STATE OF HAWAII
DEPARTMENT OF TRANSPORTATION
HIGHWAYS DIVISION

INTERSTATE ROUTE H-1
Kunia Interchange Improvements
F. A. I. Project No. 1M-HI-1(219)

SHEET No. L26 OF 52 SHEETS

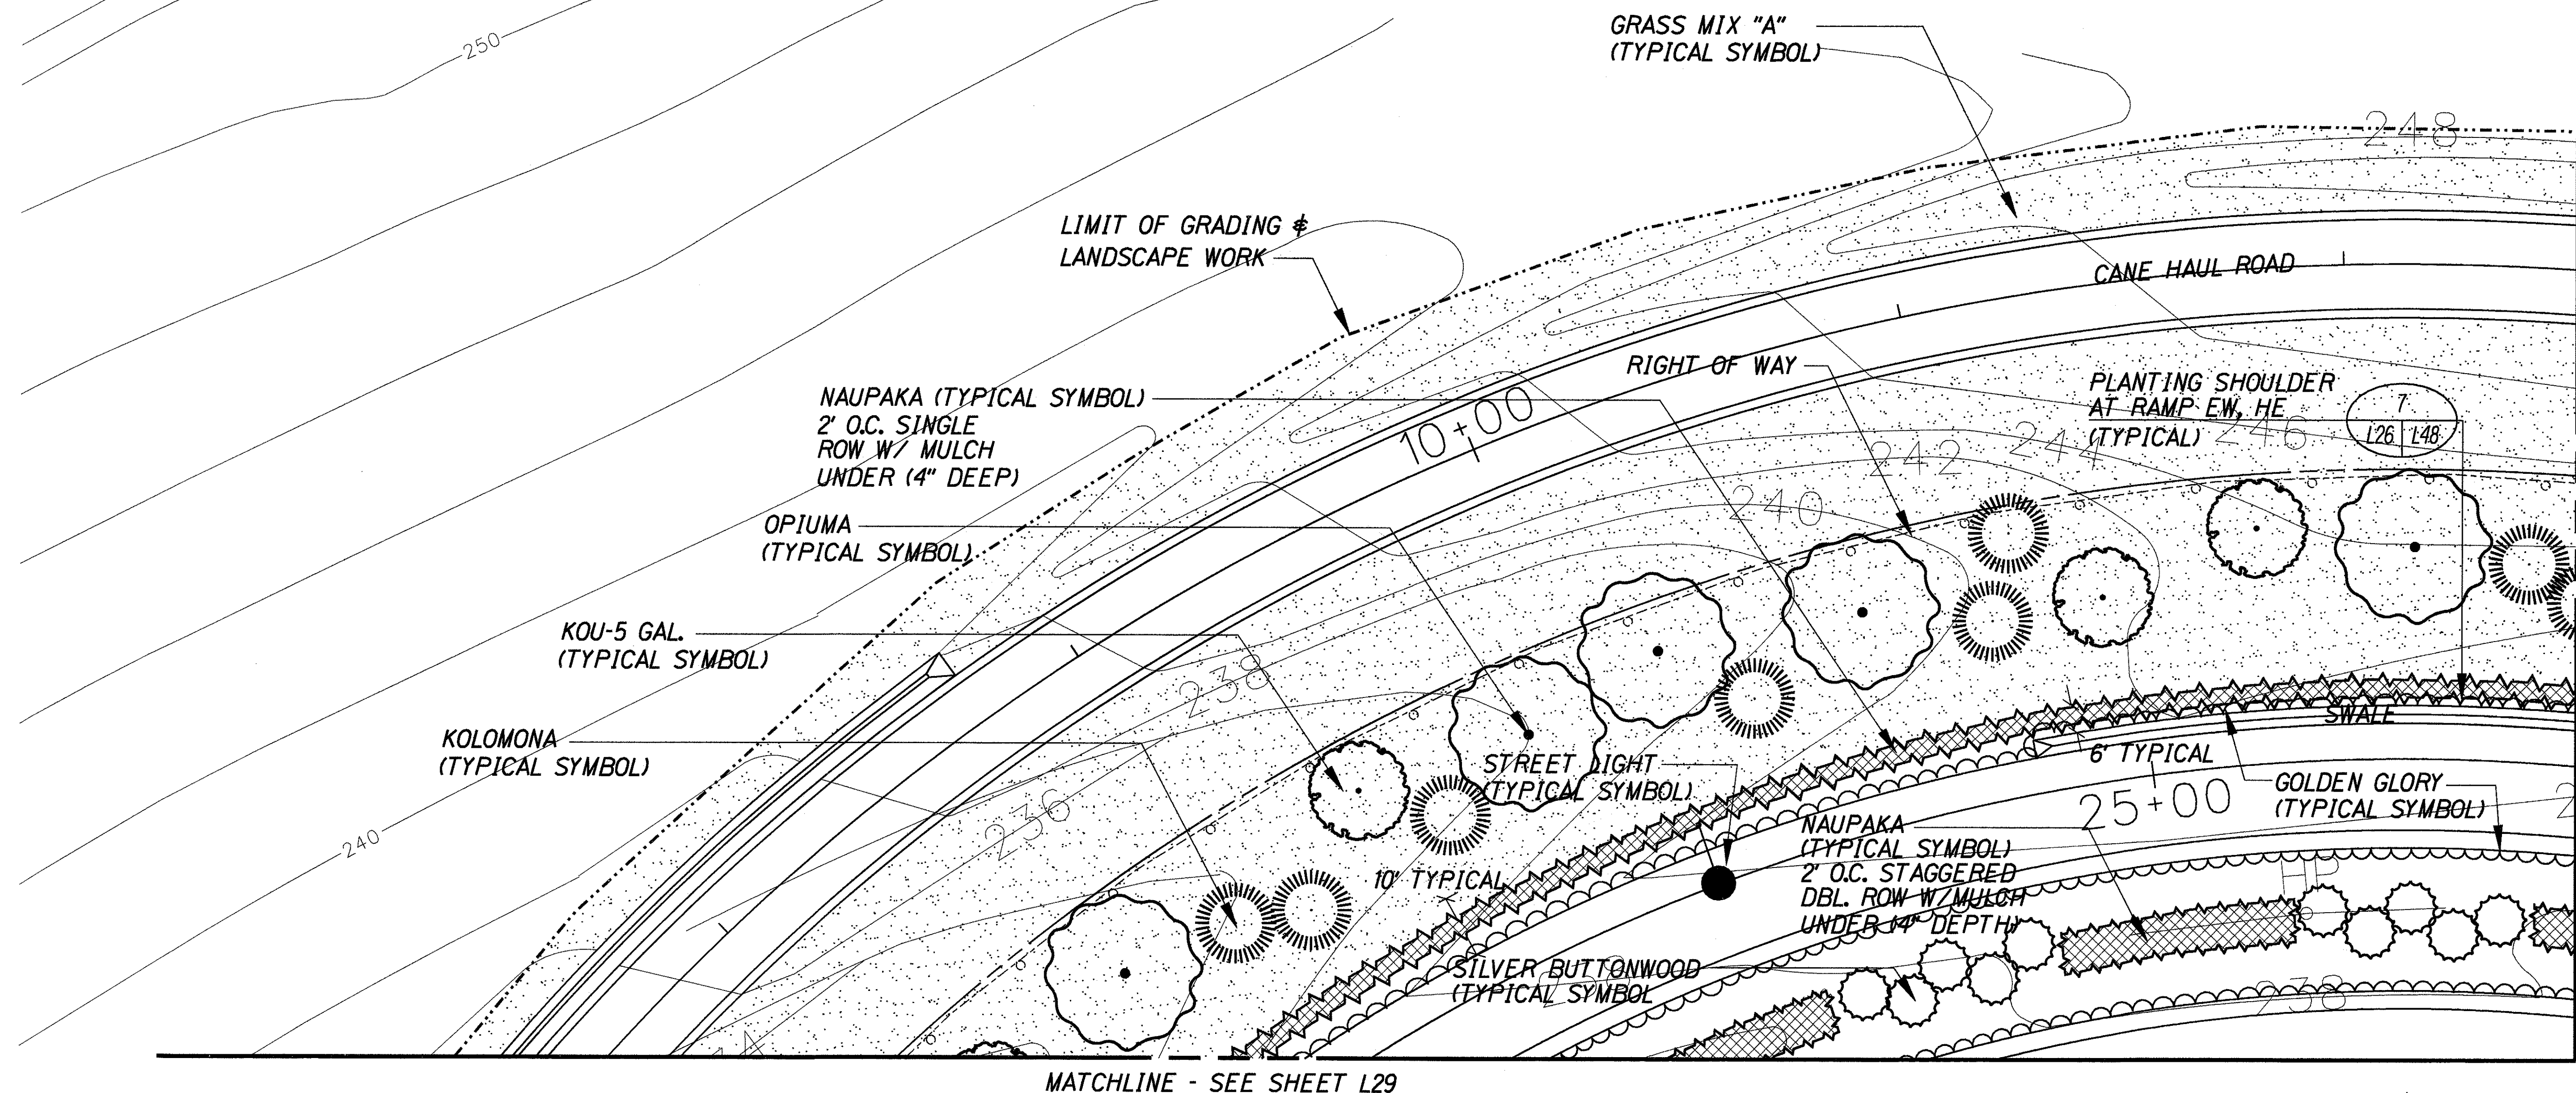
4/3/98	Revised Typical Symbol for Creeping Ilima to Read Golden Glory Per Addendum NO. 3.
DATE	REVISION

SHEET No. L27 OF 52 SHEETS

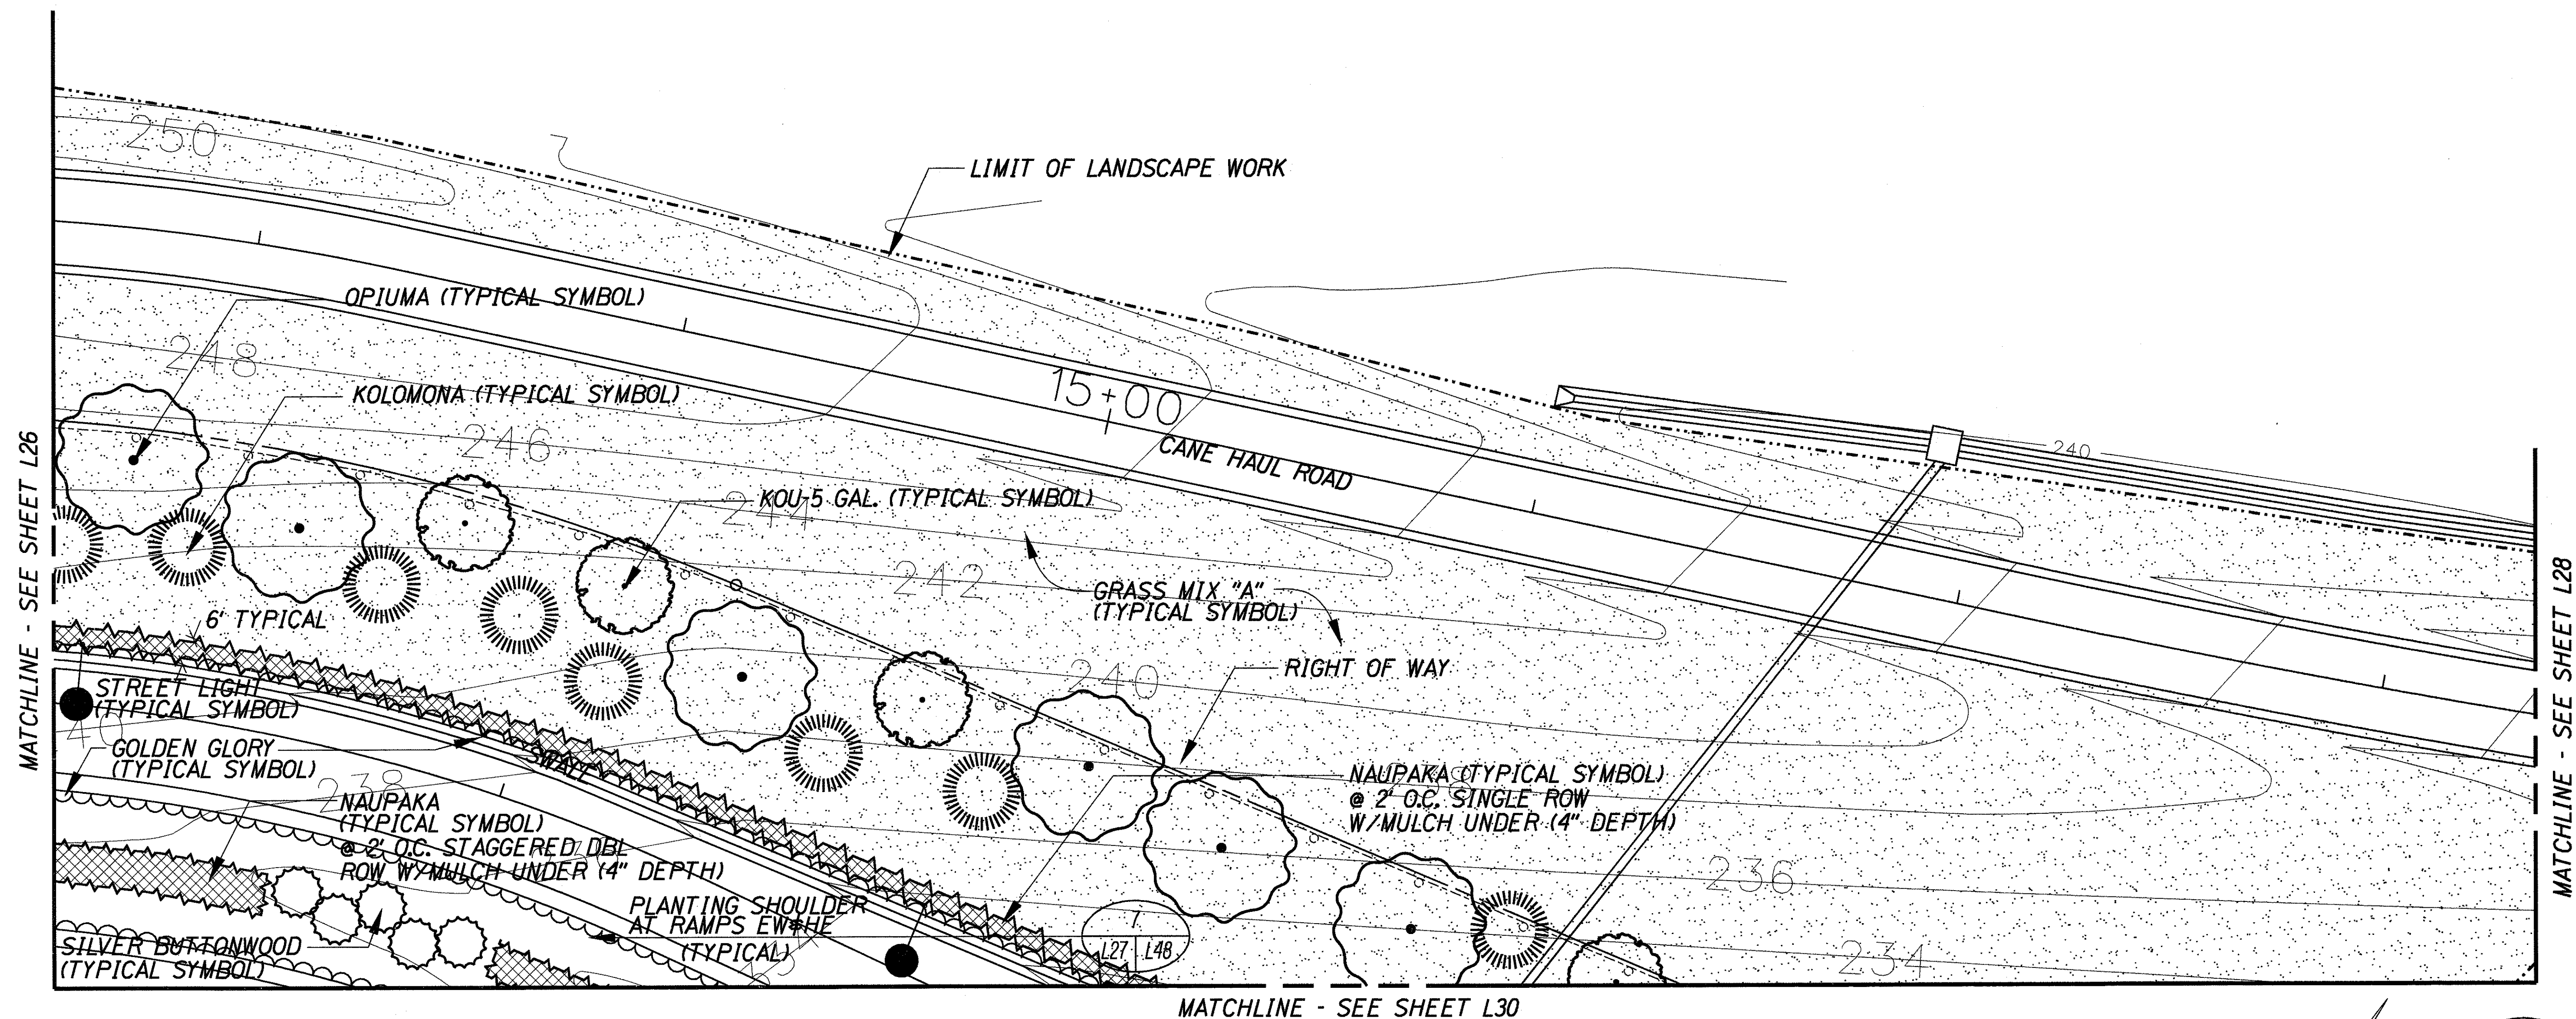
4/3/98	Revised Typical Symbol for Creeping Ilima to Read Golden Glory Per Addendum NO. 3.
DATE	REVISION

SHEET No. L30 OF 52 SHEETS

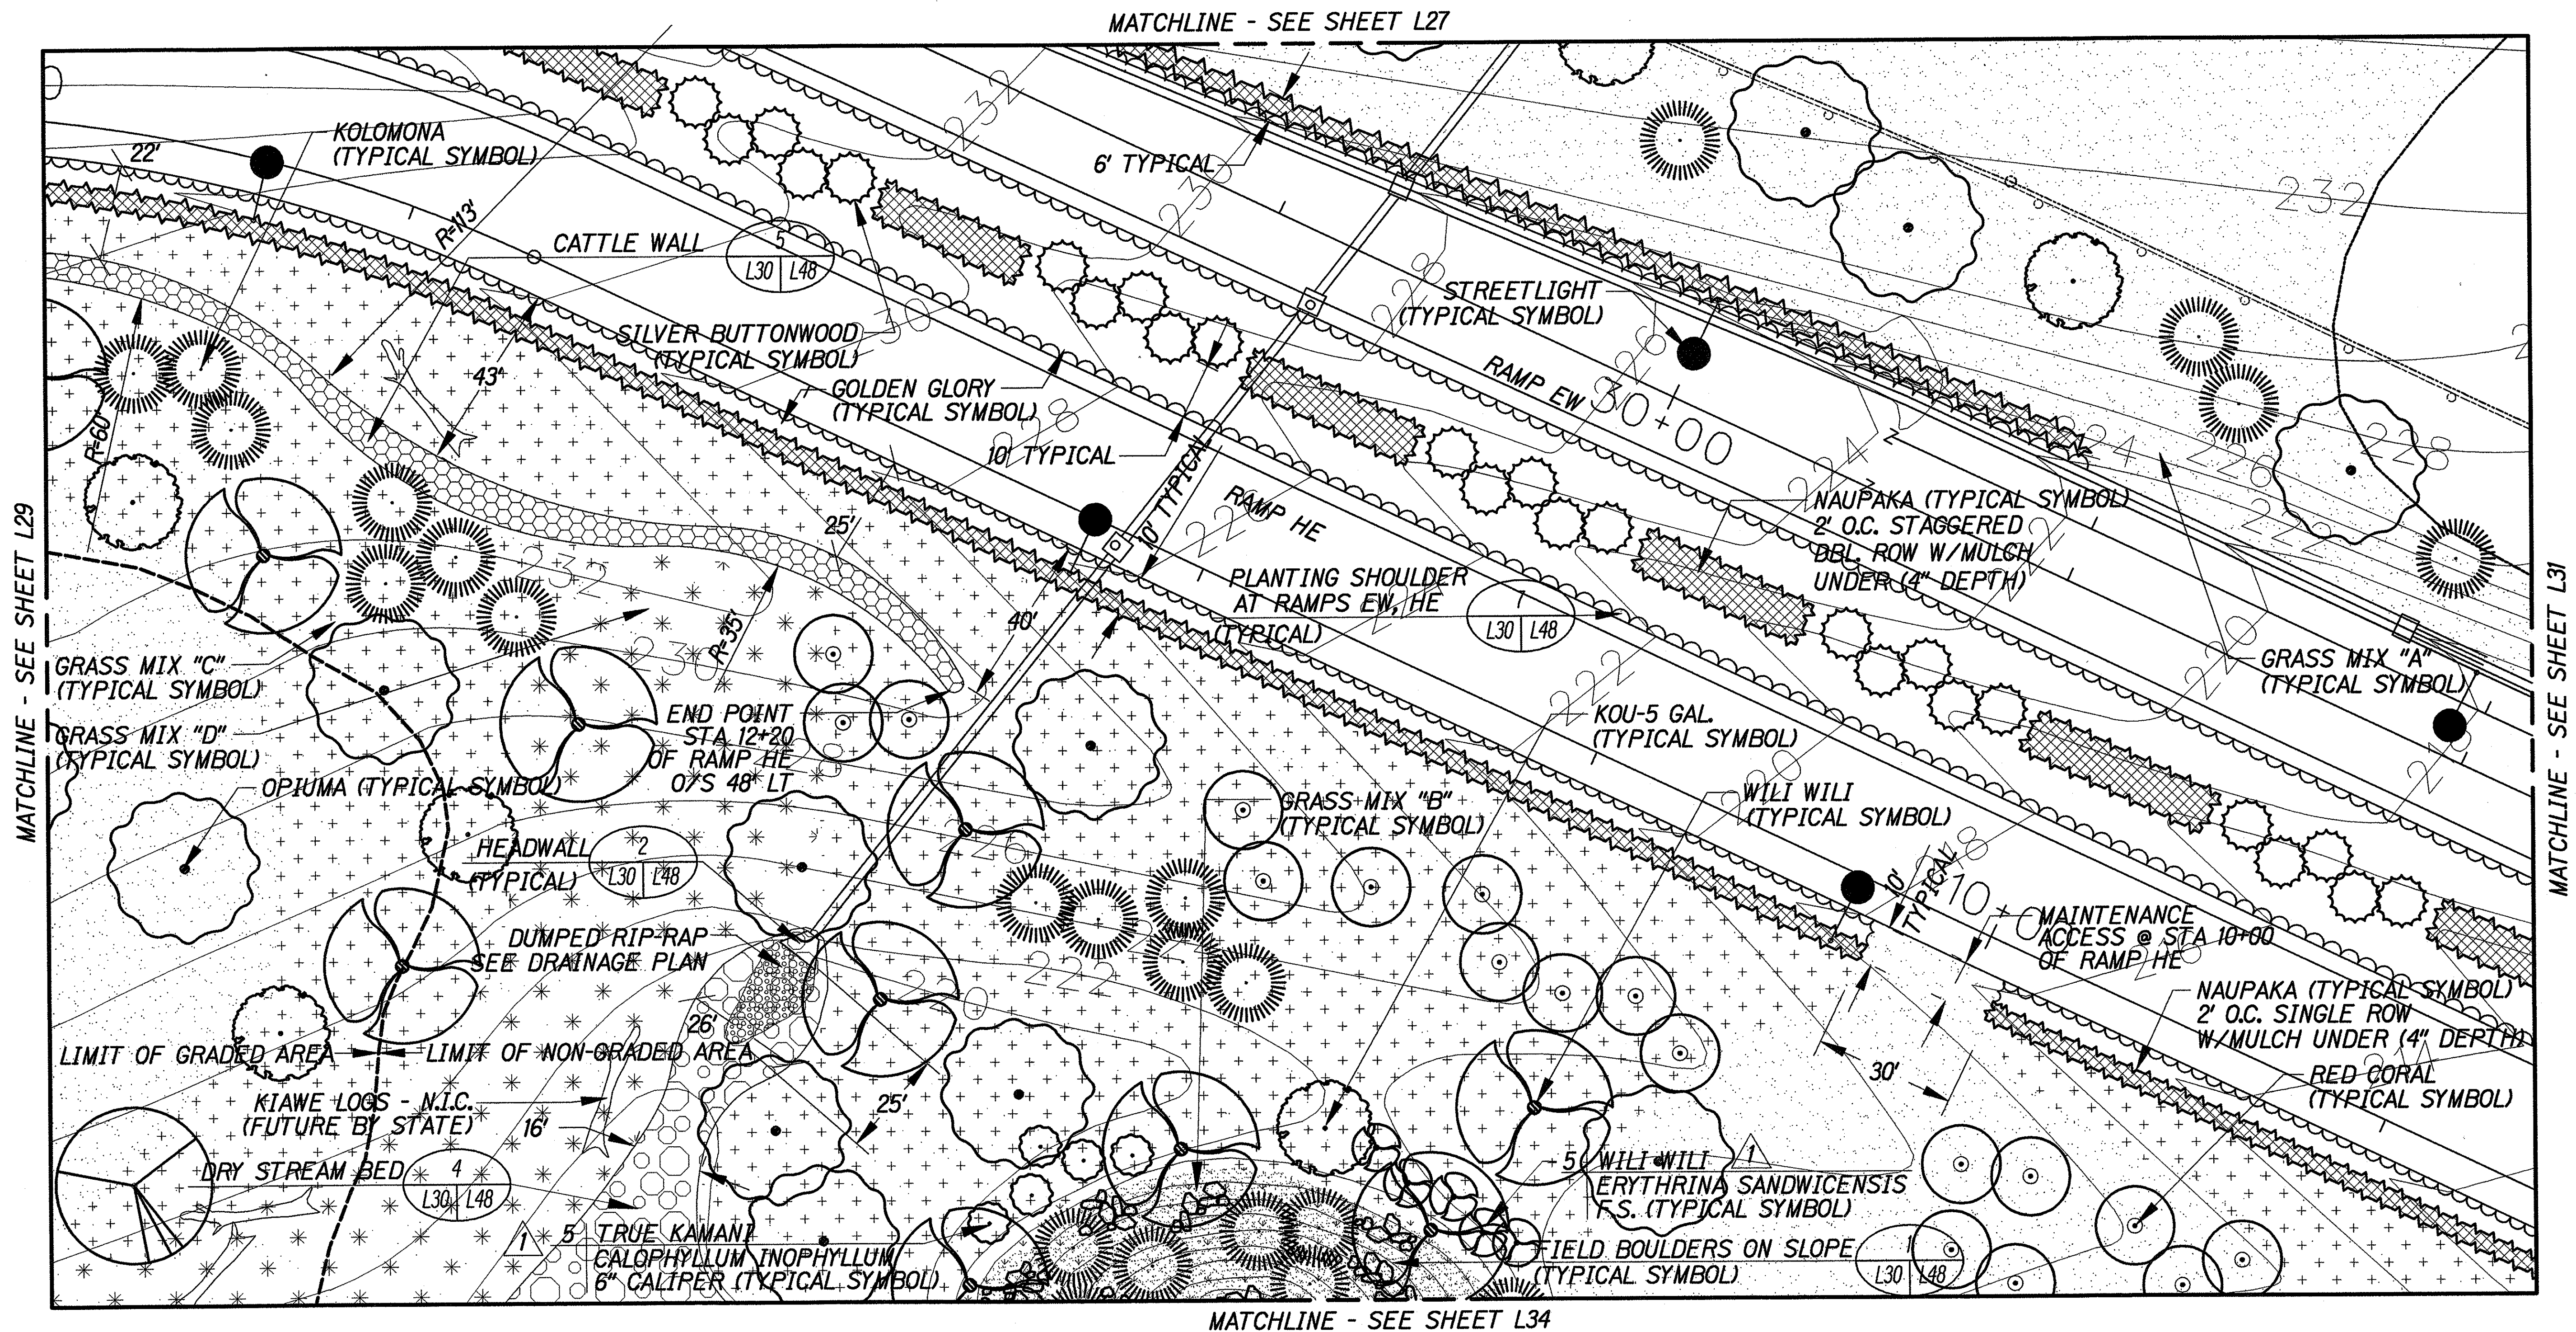
DATE	REVISION
4/30/01	Revised Planting Plan
4/14/98	Revised Typical Symbol for Creeping Illima to Read Golden Glory Per Addendum NO. 3
